UNITED STATES PATENT AND TRADEMARK OFFICE

Office Action Summary

10/670,045

HAWKINSON ET AL.

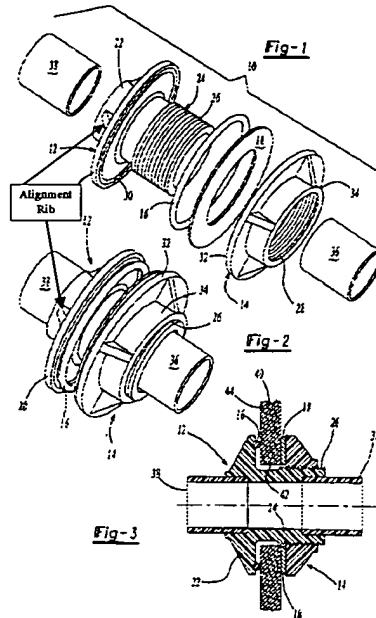
In regards to claim 4, Hawkins discloses the coupling further comprising a female-end region adjacent the first end.

In regards to claim 5, Hawkins discloses the female-end region comprising first and second sockets respectively having different internal diameters.

In regards to claim 6, Hawkins discloses the coupling further comprising a stepped internal bore having first, second, and third diameters.

In regards to claim 7, Hawkins discloses the first and second diameters respectively defining first and second sockets of a female-end region adjacent the first end and the third diameter is an internal diameter of a male-end region adjacent the second end.

In regards to claim 8, Hawkins discloses the nut further comprising an annular groove (30).

In regards to claim 9, Hawkins discloses an alignment rib (see Figures 1 and 2 below) disposed on the coupling between the flange and the second end.
